TRI-COUNTY TECHNICAL ADVISORY COMMITTEE

Friday, September 8, 2017*

ITEM 1: Review and possible recommendation of sign permits to install six signs approximately 96 inches wide by 45 inches tall and 30 square feet in the vicinity of Kirkwood Inn, Timber Creek, and East Village to Amador, Alpine, and El Dorado County. Applicant: Kirkwood Villages Development

ITEM 2: Review and possible recommendation to Amador Planning Commission for a Specific Plan Amendment and Rezone for a parking lot at the currently zoned school site in the vicinity of Loop Rd. The rezone would change 6.29 acres of Service / Utilities and Parking Zone (S-P) with parks and recreation / school overlay and 2.11 acres Multi-Family Residential (M-F) to 7.38 acres of Meadow (M) and 1.02 Service/ Utilities & Parking Zone. APNs: 026-027-031 and 026-027-018) Applicant: Kirkwood Village East, LLC

PROJECT TITLE		SHEET NO.	
KIRKWOOD - LOOP ROAD NORTH PARKING AREA		1	
DATE		SCALE	
08/08/2024		1" = 20'	
PROJECT NO.		SHEET NO.	
08/08/2024		1	
PROJECT LOCATION		CITY	
KIRKWOOD		CALIFORNIA

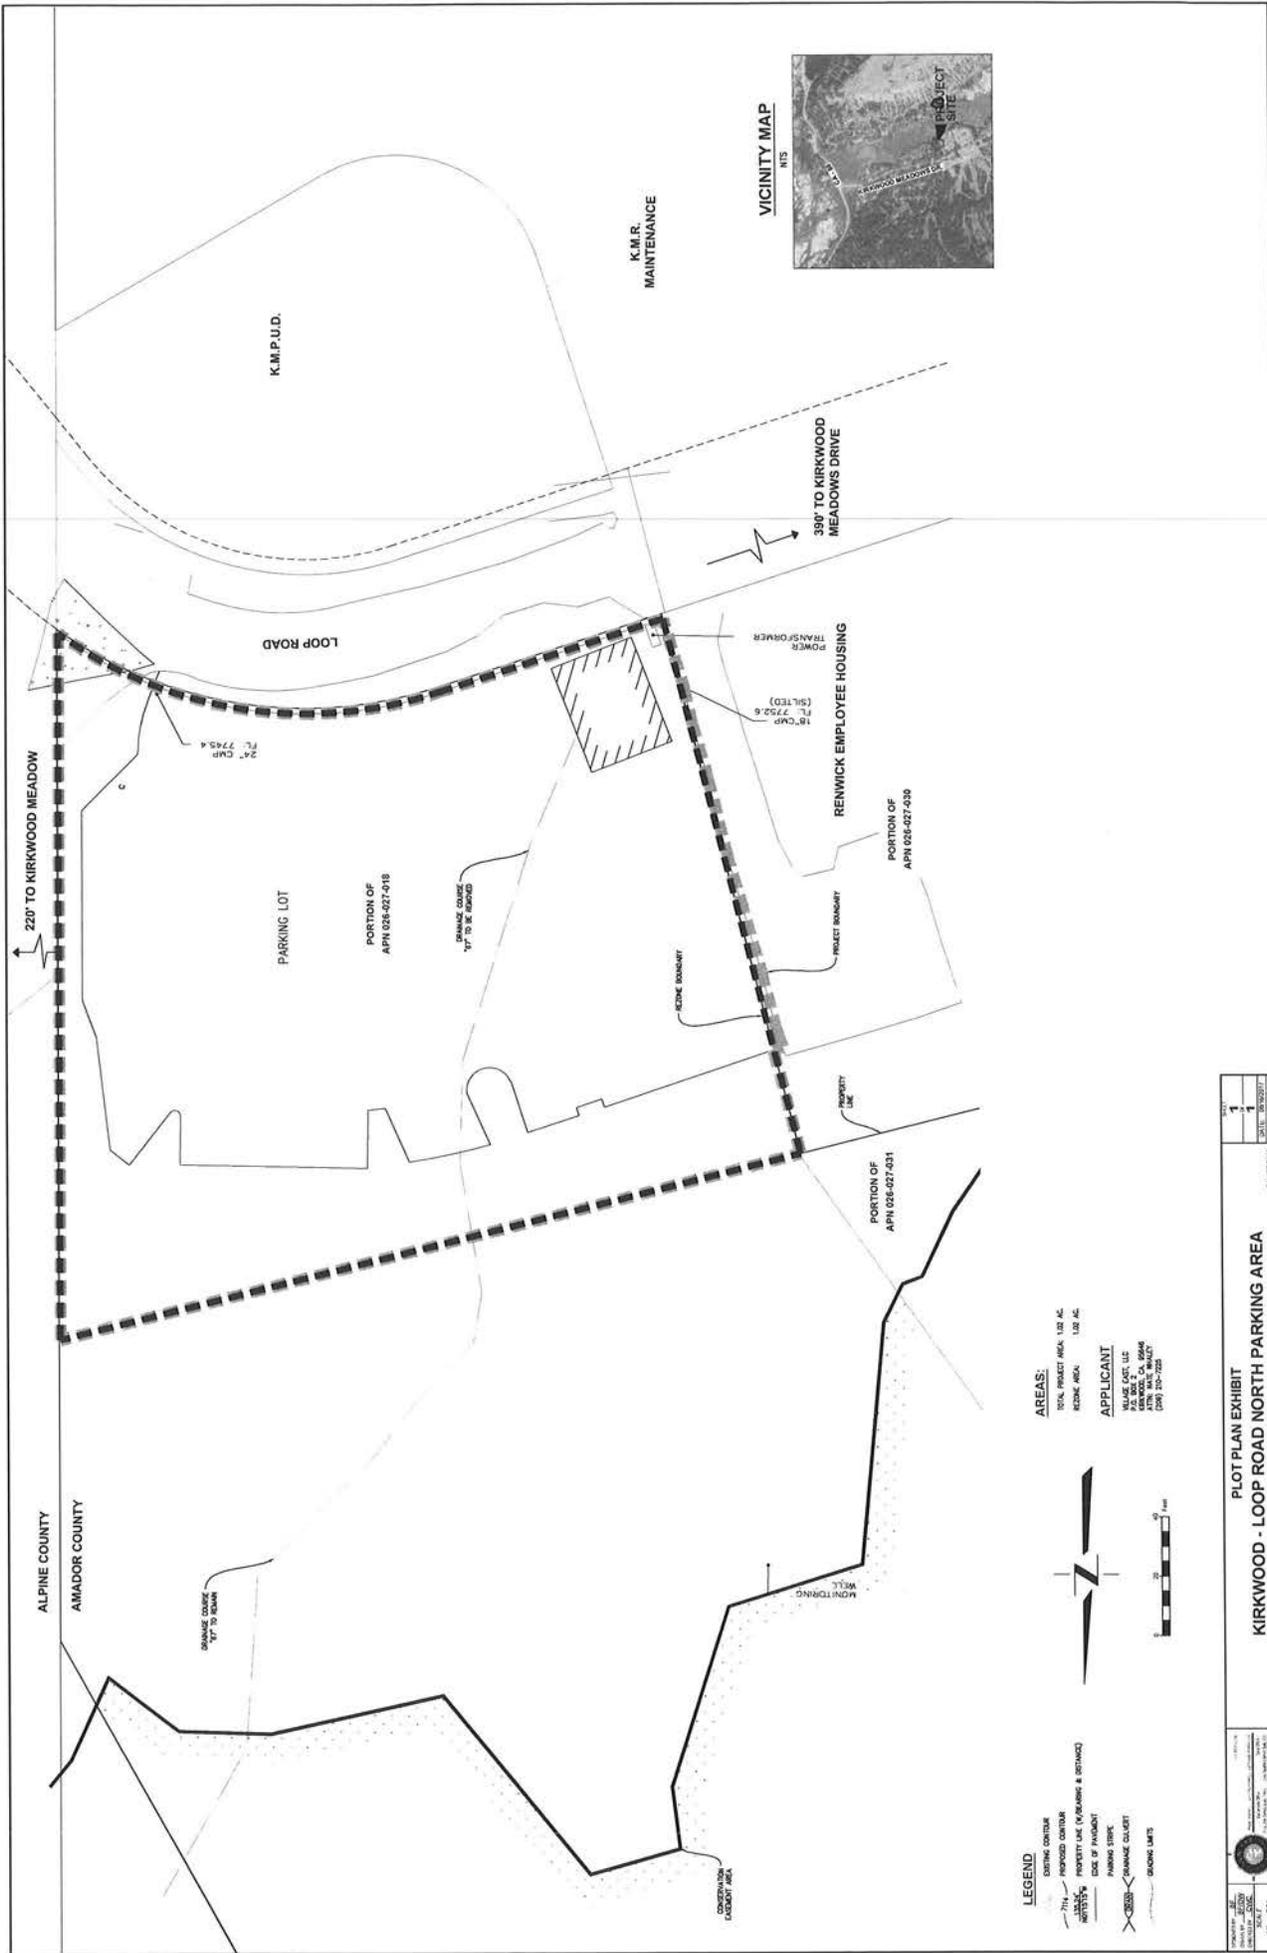
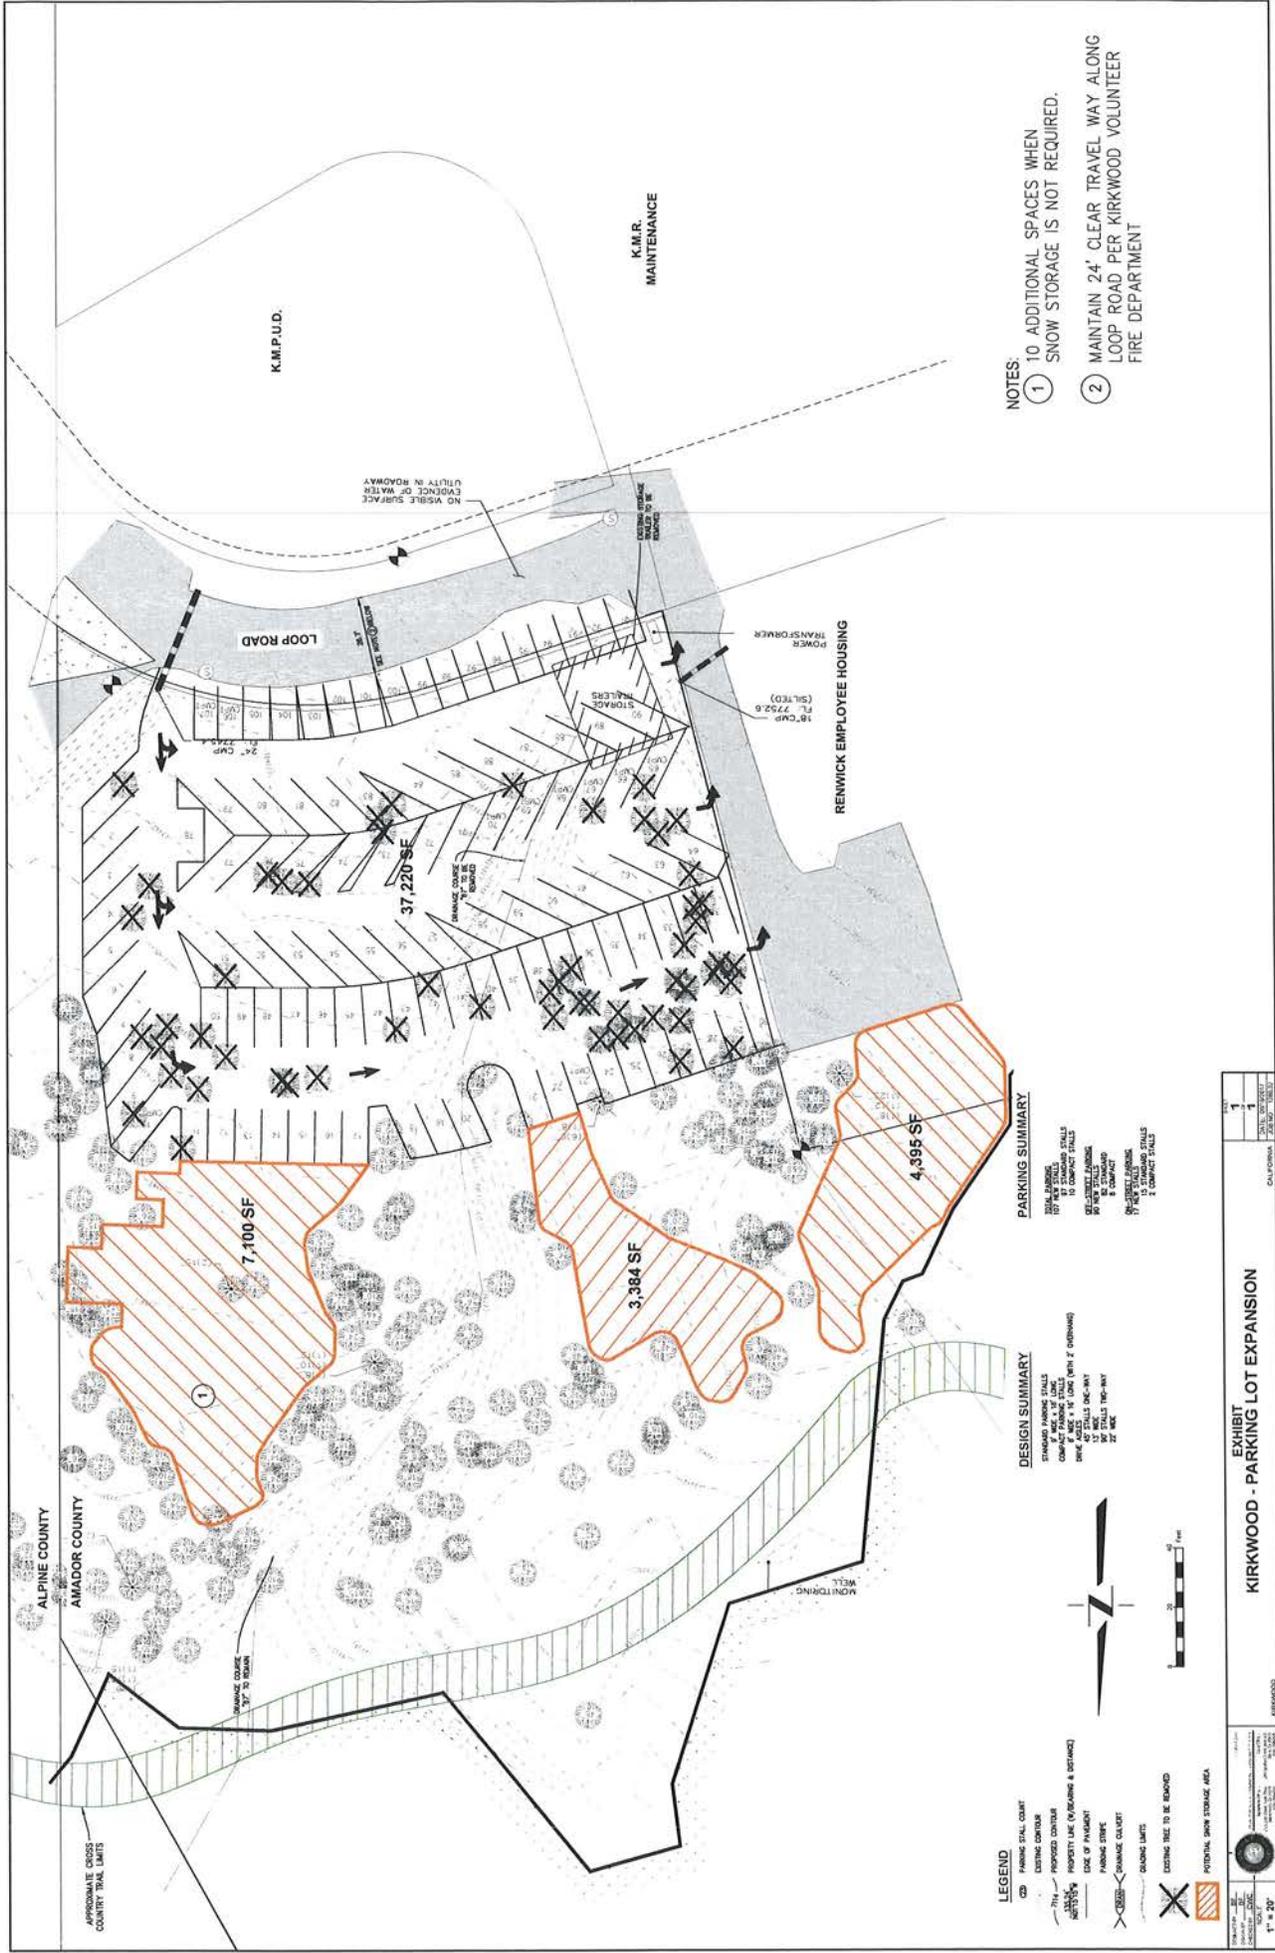
4. Although the proposal now before you reduces the size of the proposed parking lot from what was originally proposed, that is typical of Kirkwood management's tactics in the past to win approval – begin with something that is preposterous, and then fall back to something less to appear reasonable. But, a smaller version of something that is ill-conceived from the start does not make it good, just less bad. On the other side of the meadow, homeowners cannot remove even a single tree outside their building footprint, unless it is dead or presents a hazard to their homes. The lot now proposed will still impact about 50 trees directly, and it comes dangerously close to many others.

The proposed plan also impacts about 50 trees directly and comes close to many others. The reason that the trees nearest Loop Road are unattractive and are stripped of any branches except for their tops is because the Resort has consistently blown snow at these trees. If the parking lot is installed, the Resort proposes to move the snow onto the areas lined in red, odd shaped areas surrounded by trees. It is unimaginable how this snow storage could be accomplished in a precise careful manner without damaging many mature trees. Loss of ANY mature trees is a huge visual impact to all the residents who enjoy the meadow (in winter and summer) and particularly to the residents of the East Meadows. The trees on this site shield the PUD buildings and I think we can agree these are unattractive. Additionally, there are water quality concerns placing parking uphill and nearby the Kirkwood Creek.

4. The proposed Vail snow removal/storage plan for the site is unrealistic. Trees surrounding the site form a visual buffer to screen the service yard from homesite and meadow views. Proposed snow removal and storage will inevitably damage trees and other visual screening.

4. Our proposal includes designated areas for snow storage sufficient to accommodate the snow removal from the parking lot surface, consistent with the requirements in the Specific Plan. These snow storage areas are in locations where no trees exist today and the designation of the rest of the site as "Meadow" open space, ensures that the tree buffer will remain undisturbed – a commitment that does not exist today.

The limits of the proposed parking and the limits of proposed tree removal have been marked with stakes (parking extents) and yellow tape (trees) at the site for review. Note the marking was done by ourselves, not a surveyor, so while the stakes are very close to what is shown in the plan, they remain an approximation.

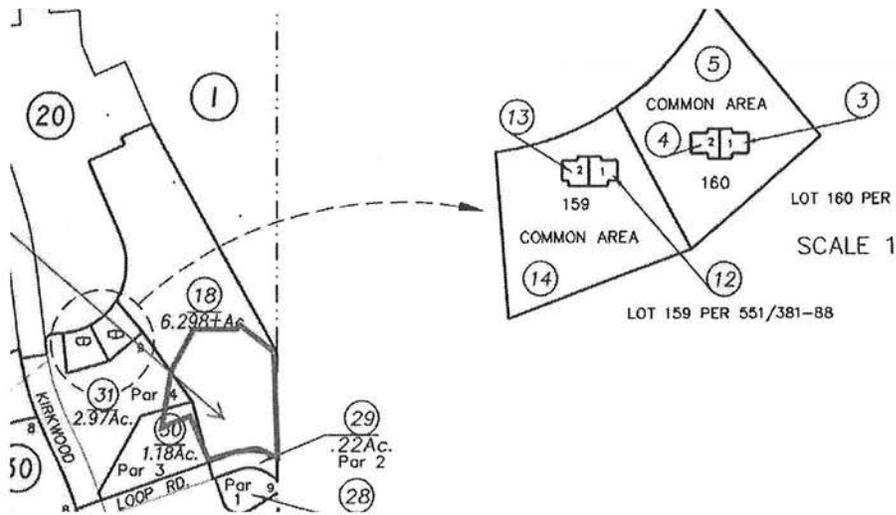
Using the land for the proposed parking lot will greatly change the contour. The entry of the parking lot is on Loop Road. The opposite ends of the proposed lots are many feet lower. The November 5, 2014 drawing of the lot I reviewed contains contour lines, but does not provide a contour interval or otherwise label the contours. (Exhibit 5.) Constructing the parking lot may entail the placement many hundreds of yards of fill, or many thousands. That there will be a substantial amount of fill can be gleaned by looking at the many closely spaced contour lines surrounding the "Existing Tree to Remain" symbol found between the two parking lots.

One thing the contour lines do show is that the proposed parking lot will lie at an oblique angle, thus giving residence of Alpine County and users of the meadow a broadside view of the asphalt.

The contour lines also show that cars are to be parked perpendicular to the fall line, which is not conducive to a parking lot covered with ice and snow. How often the cars slide into the side of each other when pulling in and out of the slots is any ones guess.

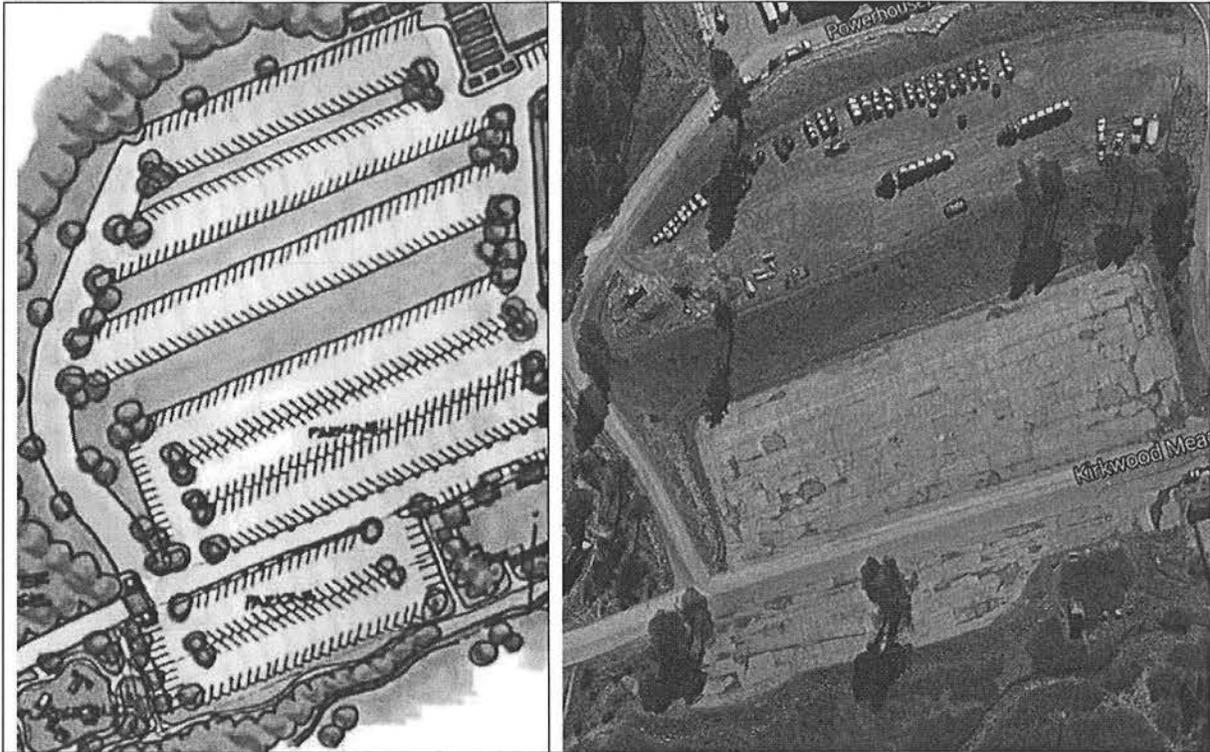
The photograph below shows the view of the homes are directed towards the proposed lot.

One of these homes is owned by my wife and myself. The view out of the front window of our house will be, under Kirkwood's proposal, a parking lot, not the current park land.

Given the presence of screening trees on the parking lot drawing, Kirkwood appears to recognize the parking lot will have a detrimental effect on scenic views, not only from the adjacent residences but also from the meadow and Alpine County. As discussed extensively in arborist John Kipping's report which accompanies this letter, any attempt to screen the parking lot and the propane tanks and other equipment on Loop Road would be futile. Not only would the screening trees not grow, the trees left in place may die, and even if they lived, would do little in the way of screening.

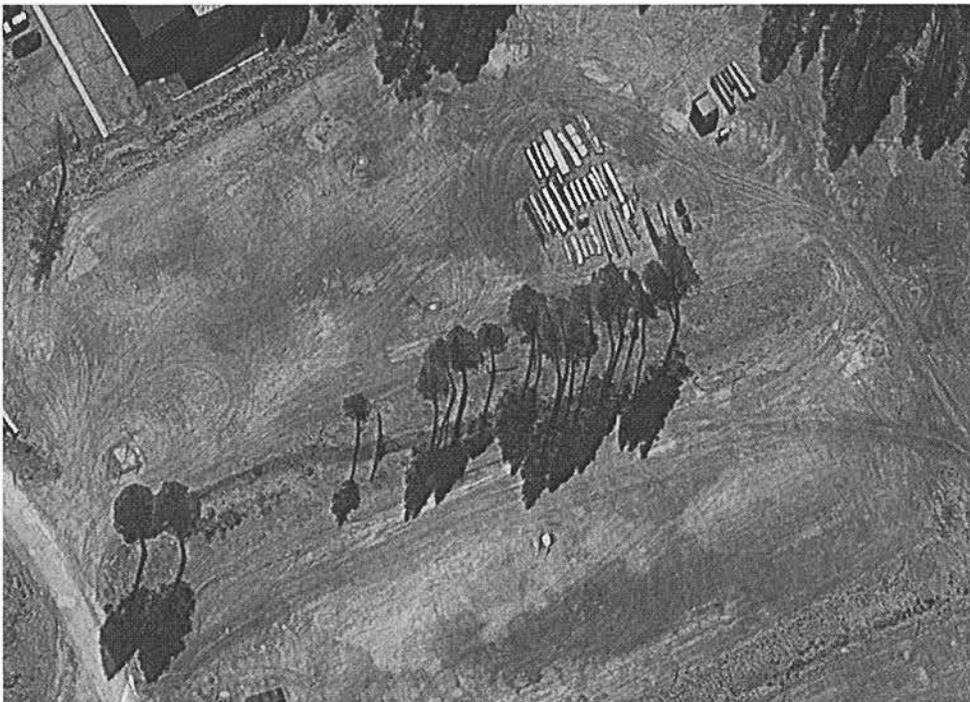
It is not difficult to draw screening trees on a plan, it is another thing to actually plant them and get them to grow. This is exemplified by Kirkwood's rendering of the Red Cliff's parking lot in the Specific Plan (below left) and a current aerial photo of the lot (below right). The only trees on or near the lot of any size are mature trees, and they have no branches on the first thirty feet or so of their trunks.

The trees left standing in the Timber Creek parking lot also have no branches for the first thirty feet.
